Atherby Rd. Retaining Wall

MEMORANDUM

RE: Atherley Road Retaining Wall
City of Orillia
FD Section WO 93-11020, Site NA
District 5, Owen Sound

SECTION 2+80

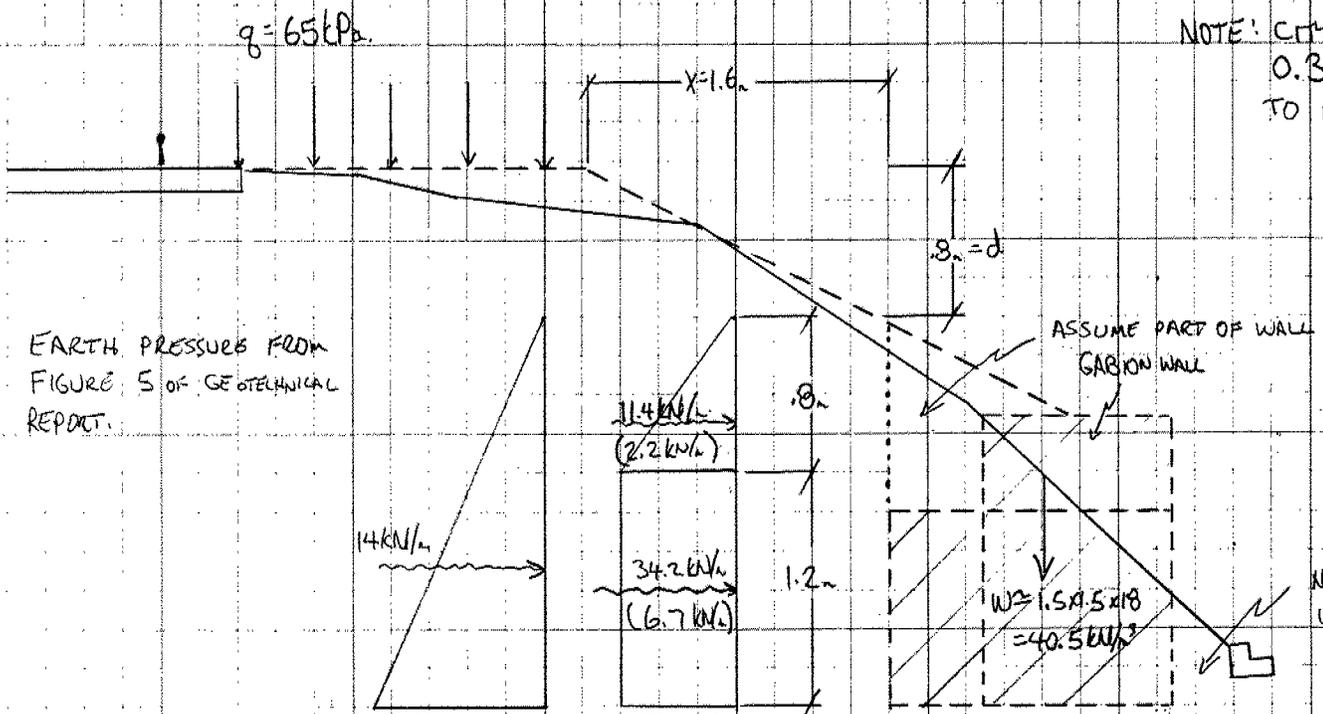
0.3m BELOW G.S.
1.5m BASE WIDTH

NOTE: CITY REQUIRES 0.9m SET BACK;
0.3m USED IN AN EFFORT
TO MAKE GABION 'FIT'

CONCLUSION: NOT STABLE
EVEN IF SURCHARGE
IGNORED!

NEGLECT PASSIVE RESTRAINT
WHERE PENETRATION IS
SHALLOW.

$$\text{F.S. SLIDING} = \frac{24.3}{(14 + 11.4 + 34.2)} = .41$$

$$\text{F.S. SLIDING} = \frac{24.3}{(14 + 2.2 + 6.7)} = 1.06 \text{ NOT ACCEPTABLE}$$

SECTION 2+80

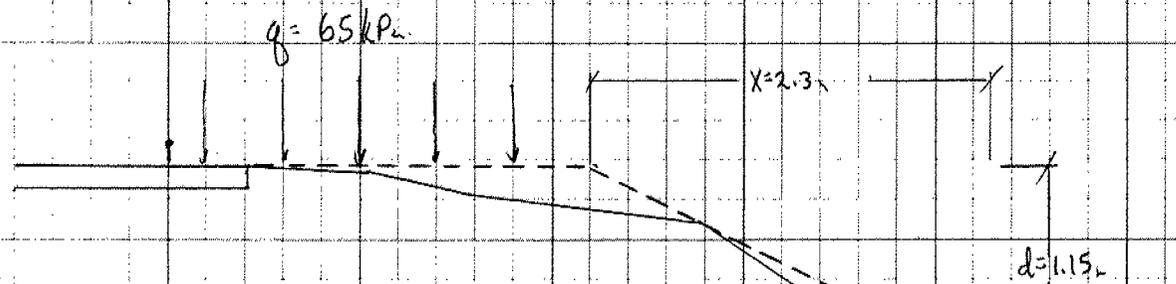
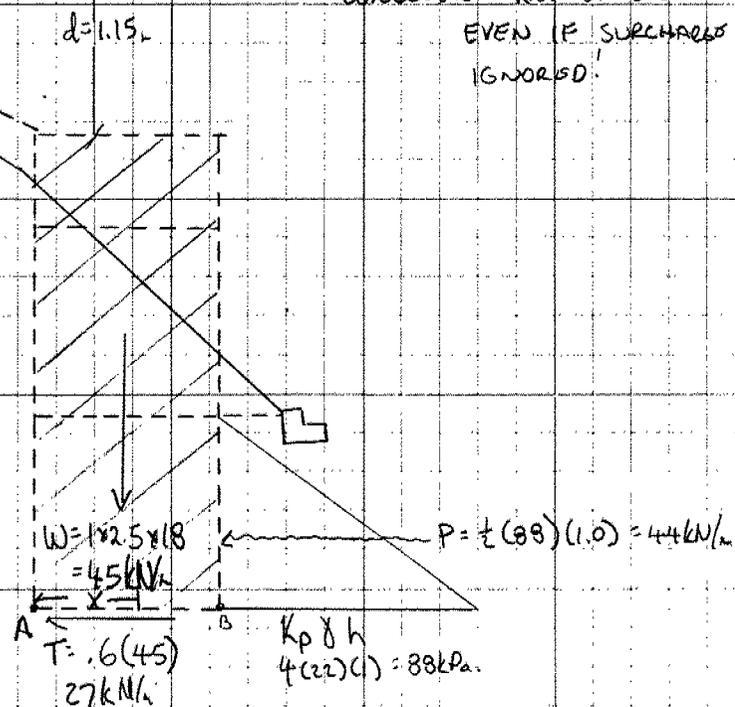
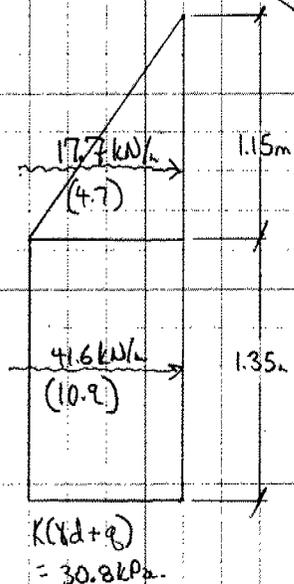
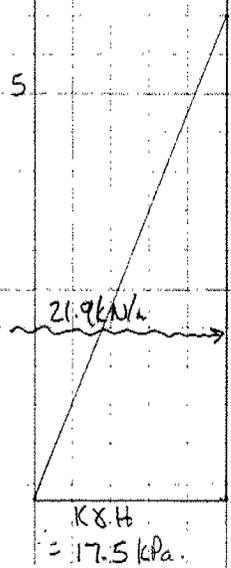
1.0m BELOW G.S.
1.0m BASE WIDTH.

NOTE: CITY REQUIRES 0.9m SET BACK;
0.3m USED IN AN EFFORT TO
MAKE GABION FIT.

CONCLUSION: NOT STABLE
EVEN IF SURCHARGE
IGNORED!

F.S. SLIDING = $\frac{27 + 44}{41.6 + 17.7 + 21.9} = .87$ WITH SURCHARGE

F.S. SLIDING = $\frac{27 + 44}{21.9 + 10.9 + 4.7} = 1.9$ NO SURCHARGE

LOCATION OF RESULTANT
 $10.9 \left(\frac{1.35}{2} \right) + 4.7 \left(1.35 + \frac{1.15}{3} \right) + 21.9 \left(\frac{2.5}{3} \right) + 45(0.5) - 44(.33) - 45x = 0$
 $x = .93 \text{m}$!! OUTSIDE MIDDLE THIRD

F.S. OVERTURNING = $\frac{45(0.5) + 44(.33)}{10.9 \left(\frac{1.35}{2} \right) + 4.7 \left(1.35 + \frac{1.15}{3} \right) + 21.9 \left(\frac{2.5}{3} \right)} = \frac{37.02}{33.8} = 1.1 < 1.5$

SECTION 2+80

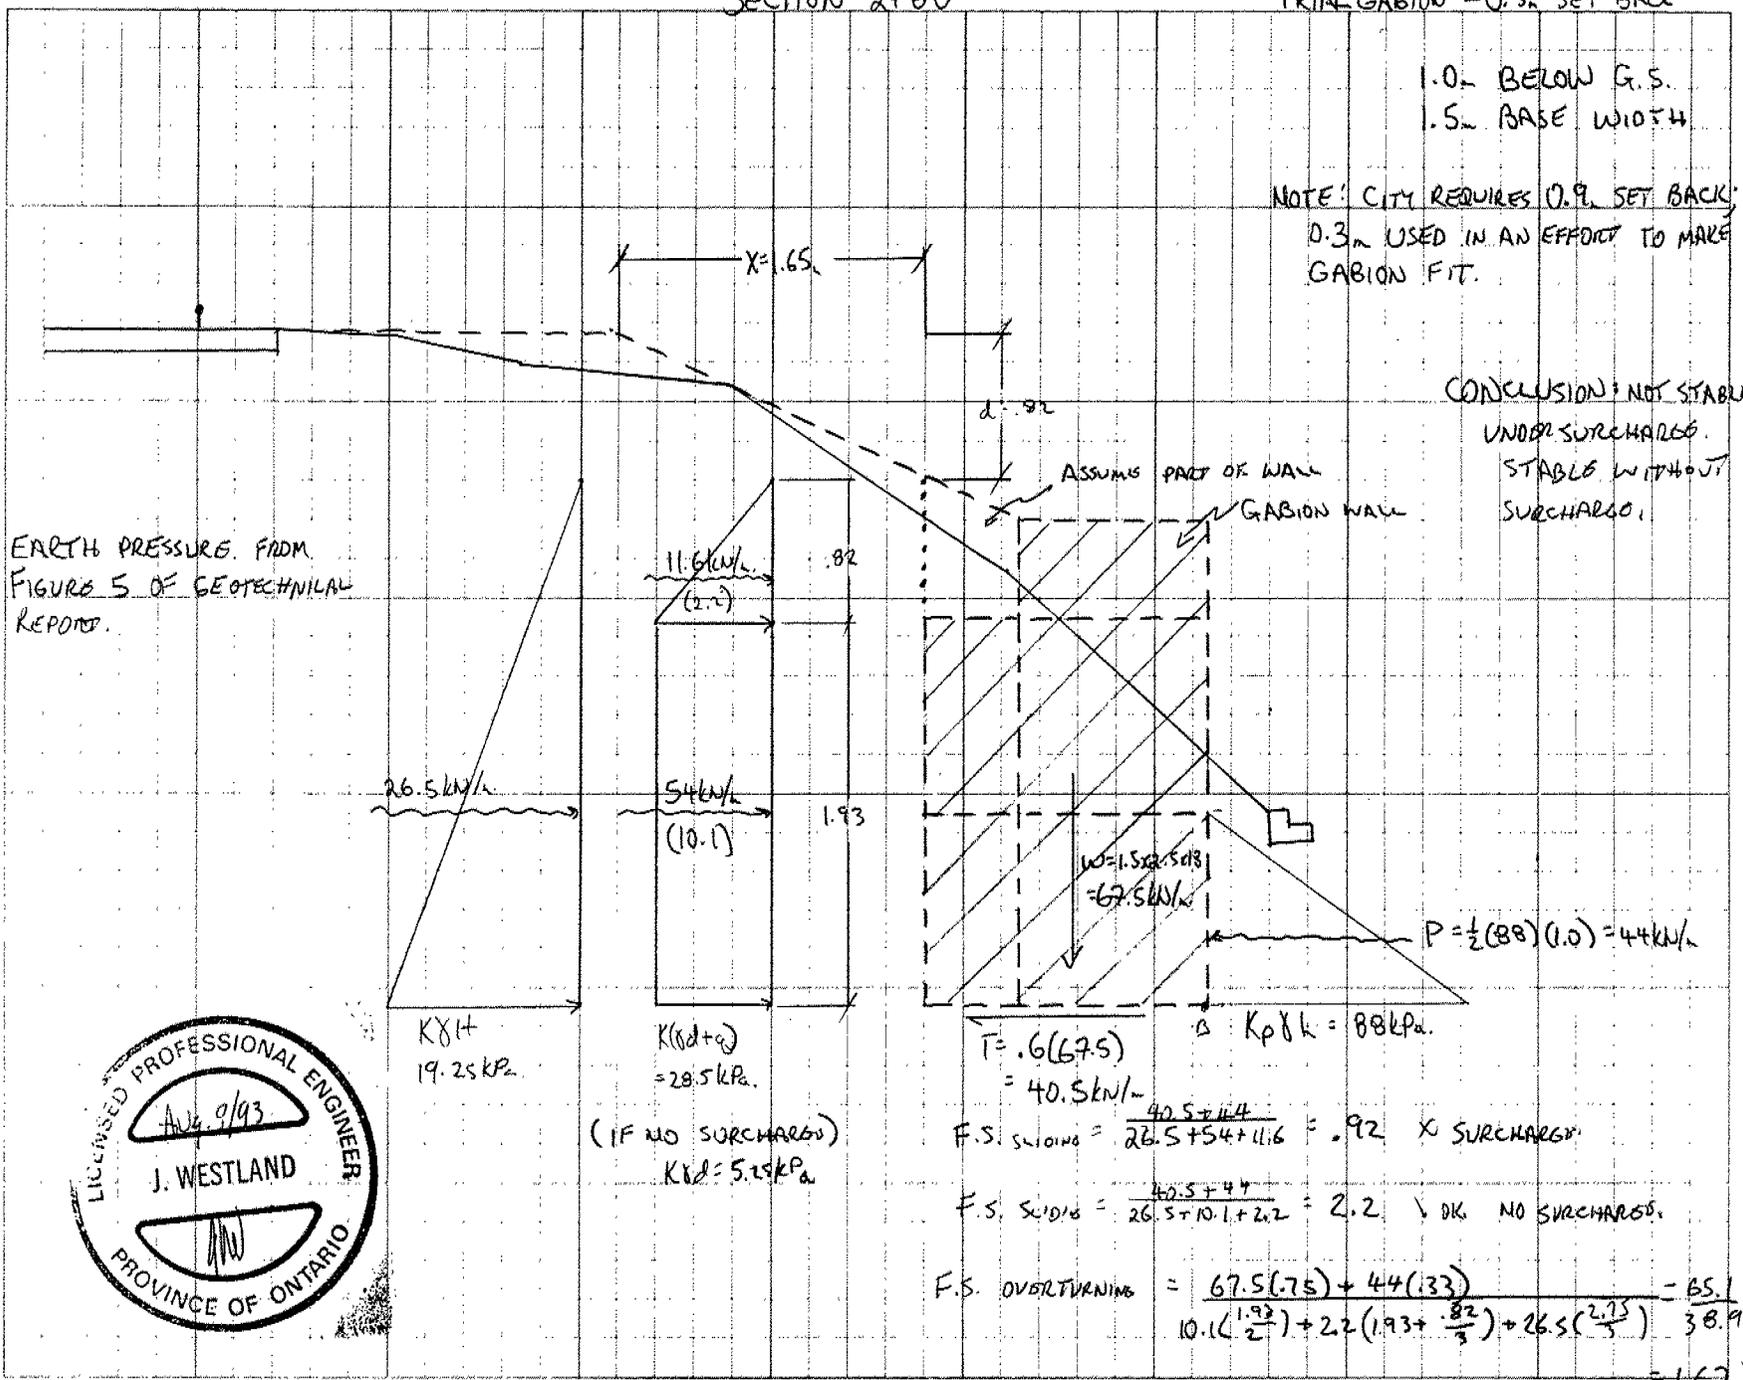
1.0m BELOW G.S.
1.5m BASE WIDTH

NOTE: CITY REQUIRES 0.9m SET BACK.
0.3m USED IN AN EFFORT TO MAKE GABION FIT.

CONCLUSION: NOT STABLE UNDER SURCHARGE.
STABLE WITHOUT SURCHARGE.
